ZC Case No. 15-28 - PUD Modification
Address: 301 N St NE Washington, DC 20002

FILLAT+ ARCHITECTURE
PLAN REVIEW - PRESENTATION

PRESS HOUSE HOTEL
24006 - 301 N St NE Washington, DC 20002

ZONING COMMISSION
District of Columbia
CASE NO. 15-28A
EXHIBIT NO. 20B1
FILLAT+
ARCHITECTURE

PROPOSED AERIAL VIEW - NORTHWEST #1

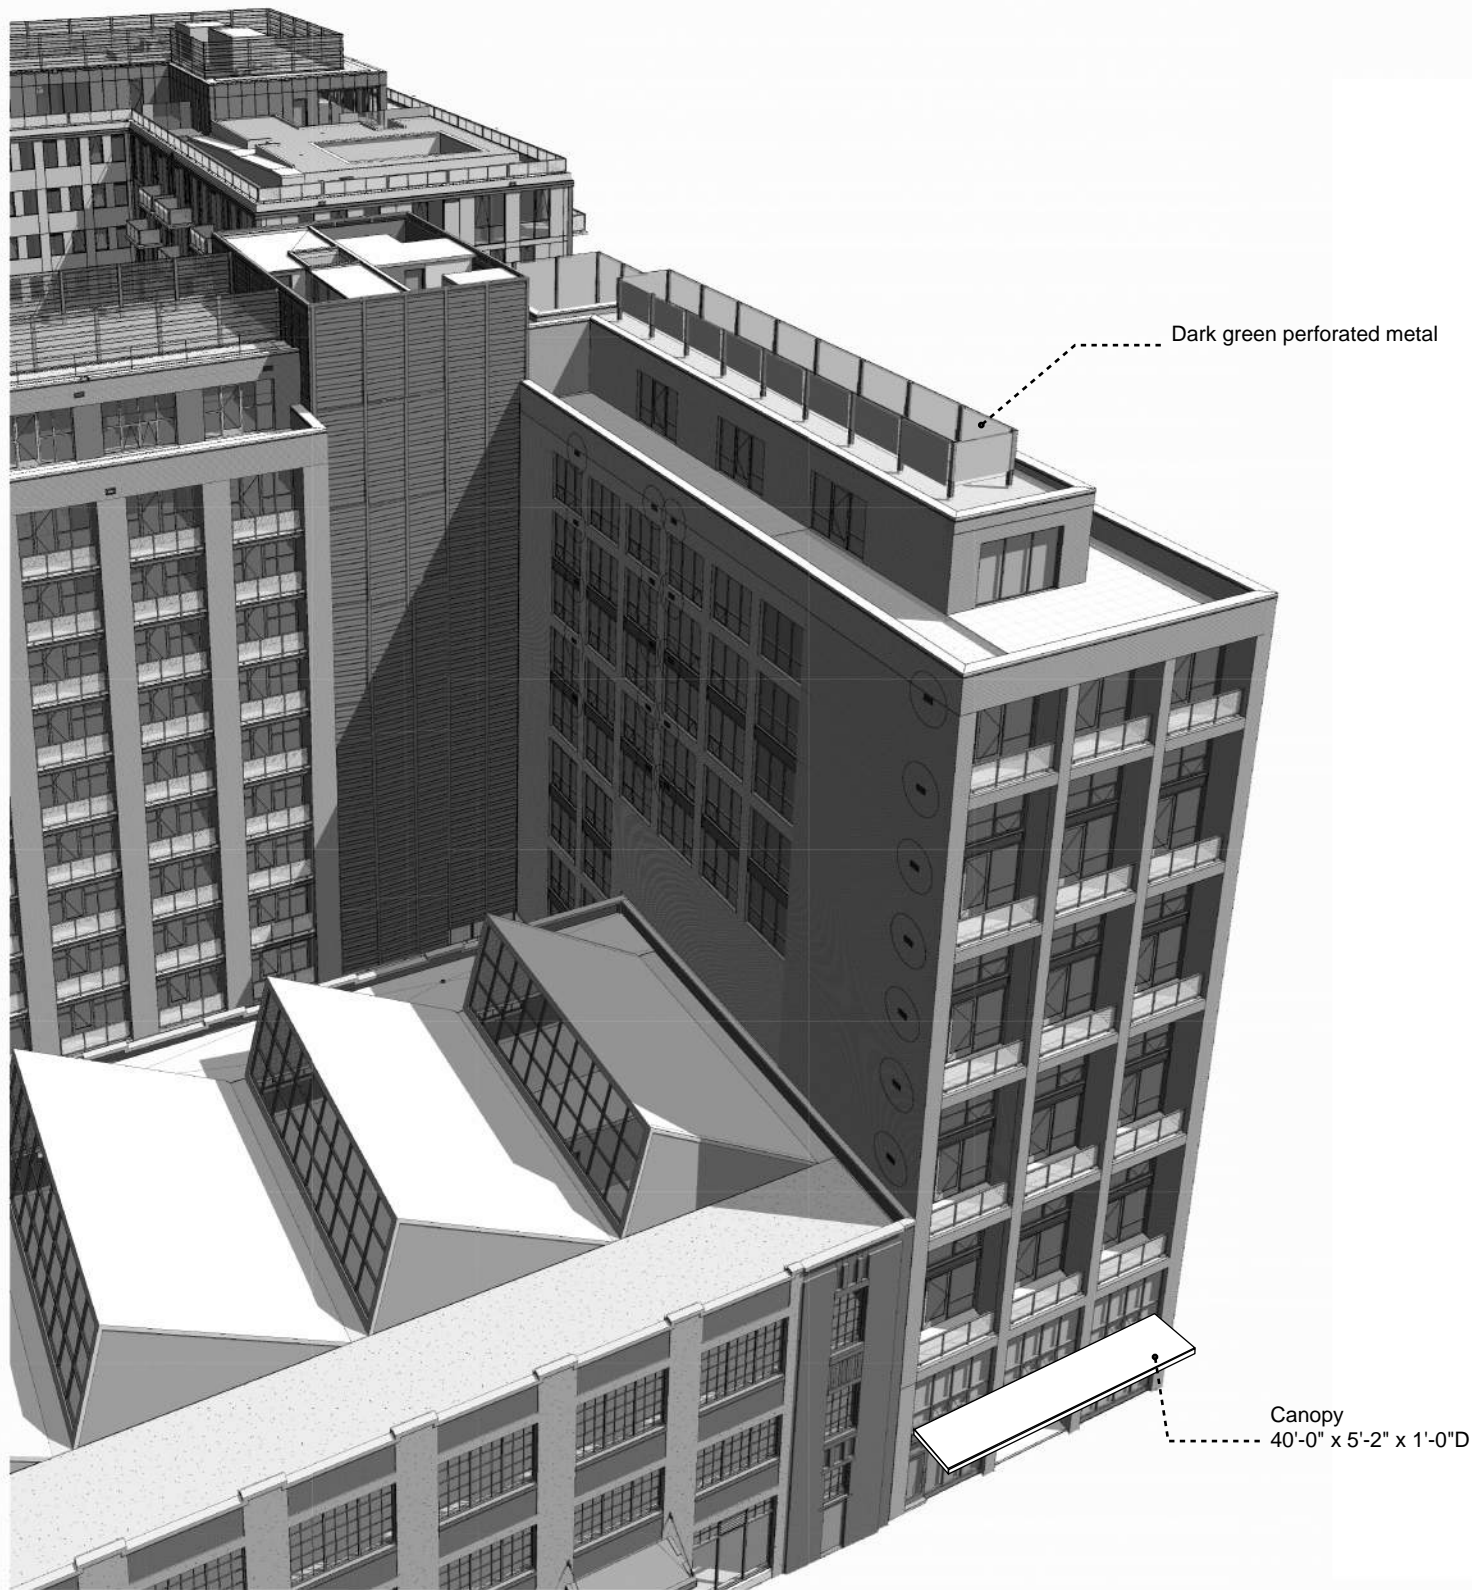
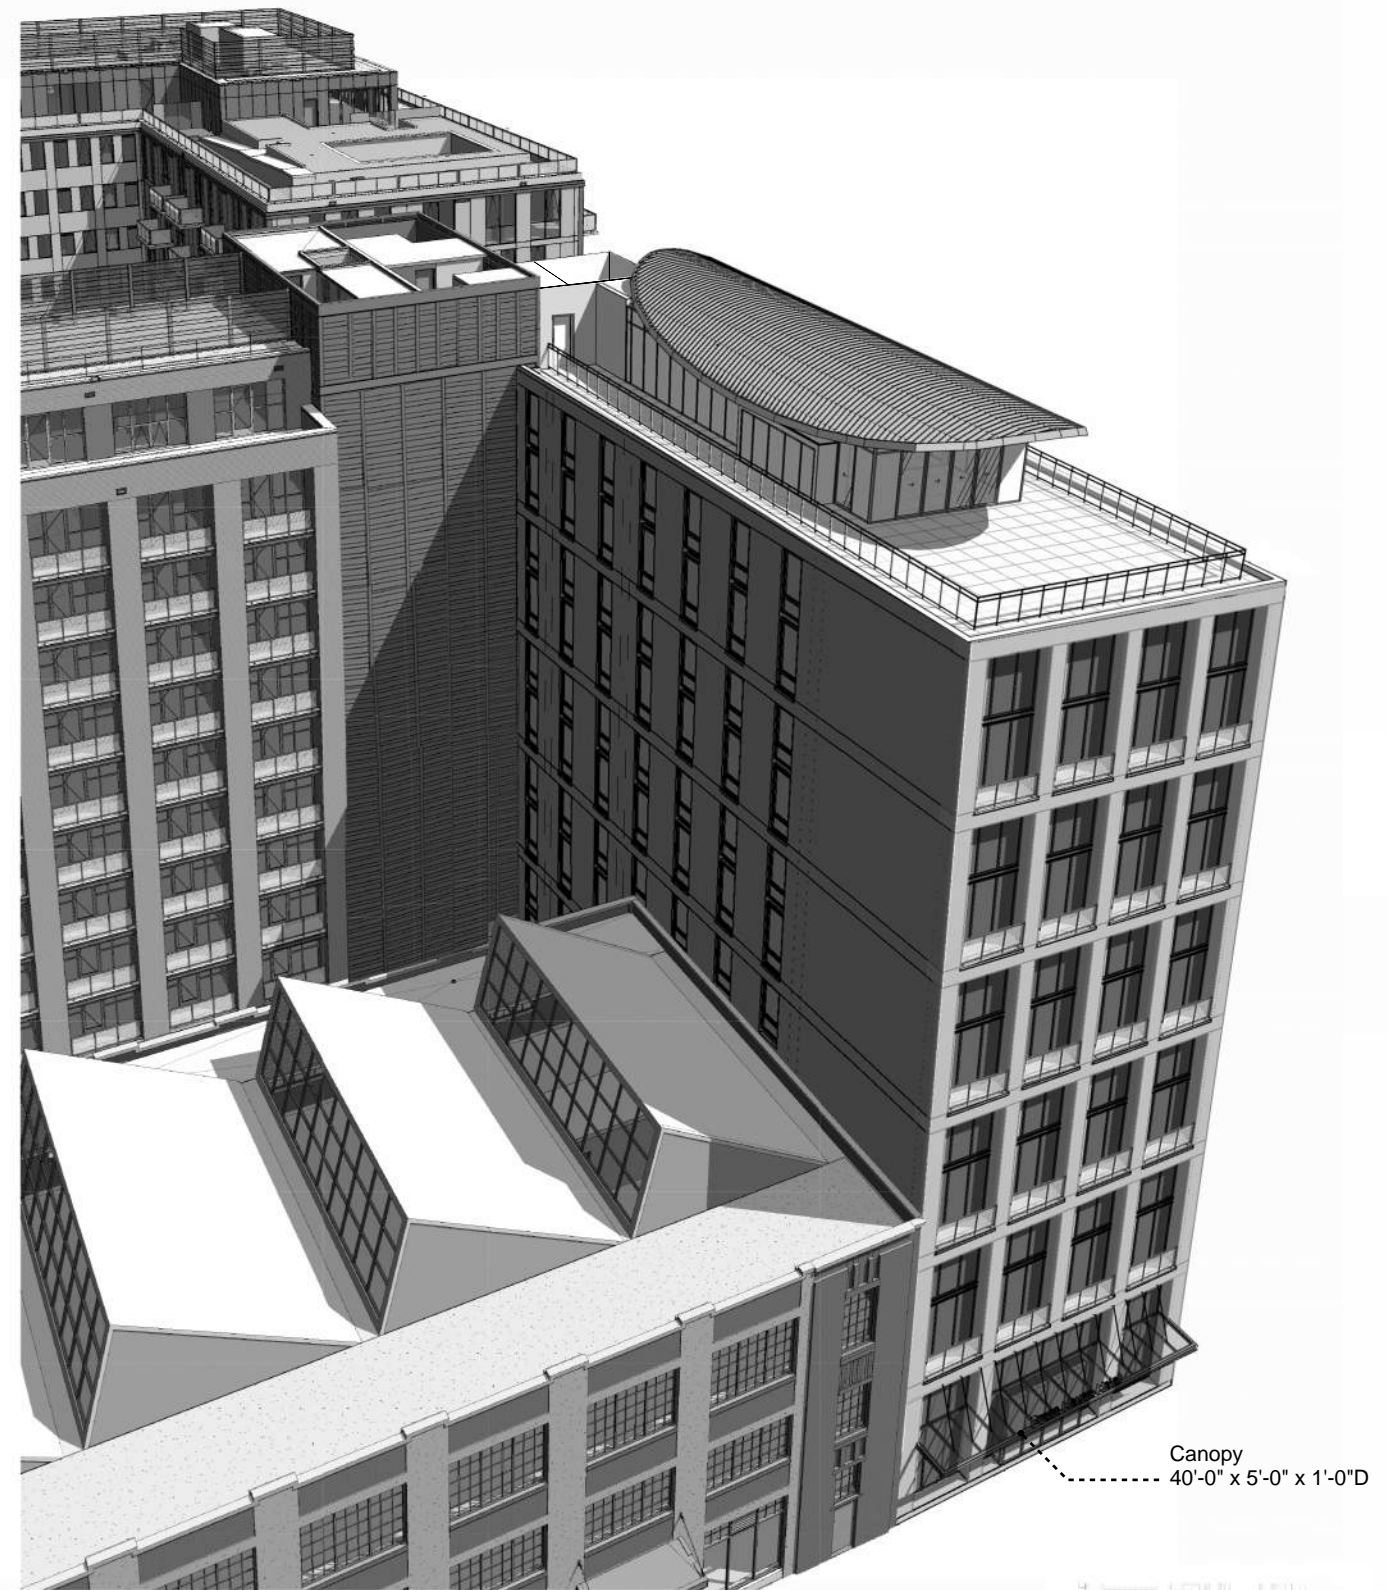
Pursuant to Z.C. Order No. 15-28, Conclusions of Law 6, the Commission granted flexibility for penthouse setback. Additional flexibility is not required for the expanded mechanical penthouse on the east side of the hotel building. Since the Commission approved the initial PUD, the penthouse regulations have been amended. Currently, per Subtitle C, Section 1504.1(c)(3), a 1:1 setback is only required along a side building wall when the adjacent property along the shared side lot line has a lower permitted matter-of-right building height. Since both 301N and 331N were rezoned to the same zone as part of the approved PUD, and thus may achieve the same matter-of-right building height, a 1:1 penthouse setback is not required along the shared side lot line.
